4. DESCRIPTION OF AMENDMENT.
Project Number: 3770-21-000032 – Global Reach Express Image Update – Fort Bliss.

**Questions and Responses to Solicitation No. GNFR-FC-BLS-23-18533
Global Reach Express 2.0 Image Update (Fort Bliss, TX)**

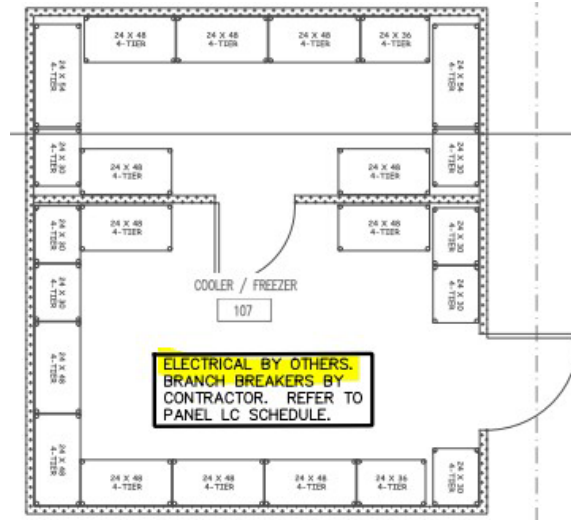
3. **Question:** Is AAFES or the contractor responsible for temporary storage for the outdoor dry storage during the demolition of the dry storage area? Who is responsible for the relocation of the materials under this space?

Response: AAFES is responsible for the temporary dry storage and relocation of products.
